**Road vehicles — Anchorages in vehicles
and attachments to anchorages for child
restraint systems —**

**Part 1:
Seat bight anchorages and attachments**

**AMENDMENT 3: Specifications for the
detection of use of ISOFIX CRS**

Amendment 3 to ISO 13216-1:1999 was prepared by Technical Committee ISO/TC 22, *Road vehicles*, Subcommittee SC 12, *Passive safety crash protection systems*.

Figure 8.1 — Maximum dimensions of the connector

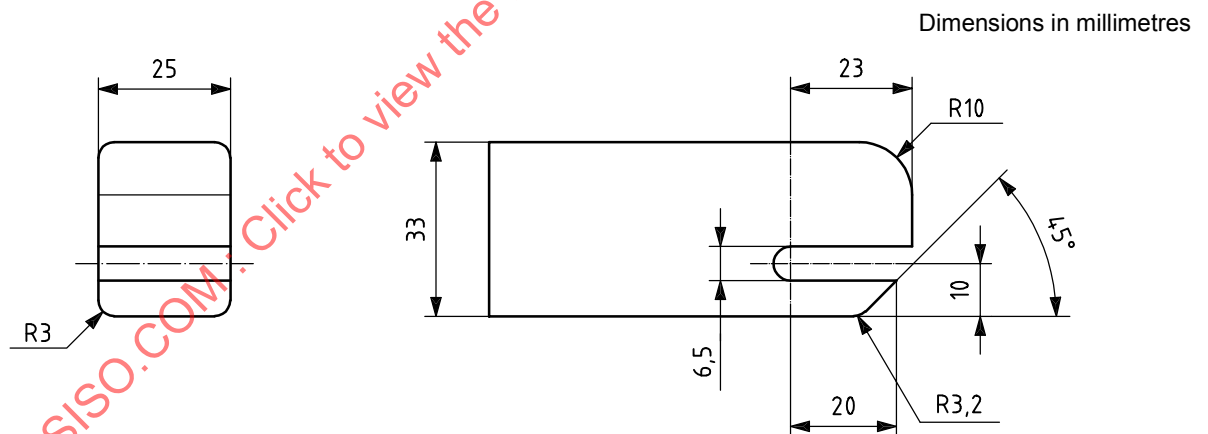
Modify 5.2.2 as follows.

Dimensions for the portion of the CRS connector that engages the anchorage bar shall not exceed the maximum dimensions given by the envelope in Figure 8.1 and not be less than minimum dimensions given in Figure 8.2.

Figure 8.3 — Maximum clearance between latch and ISOFIX bar

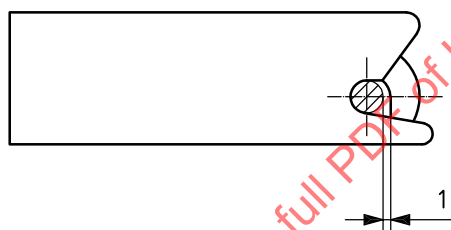
In the locked position around the ISOFIX bar, the maximum clearance between latch and bar shall not be greater than 1,5 mm (see Figure 8.3).

Figure C.1 — Detection test apparatus — side and plan views

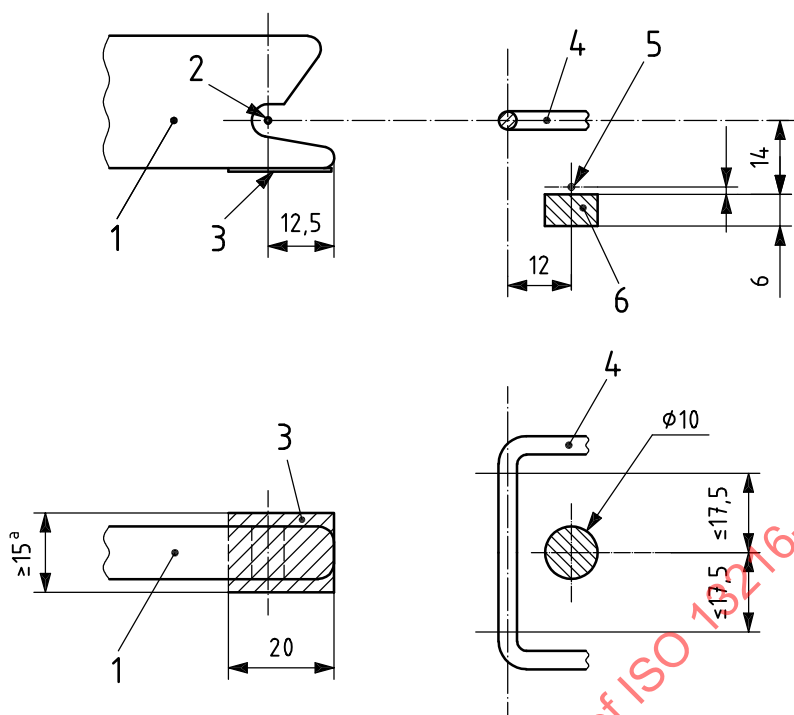
After Annex B, page 18, add Annex C as follows.

The principle of detection is based on the variation of a magnetic field when the ISOFIX connector of the child seat moves forward the ISOFIX anchorage bar of the vehicle.

See Figure C.1.
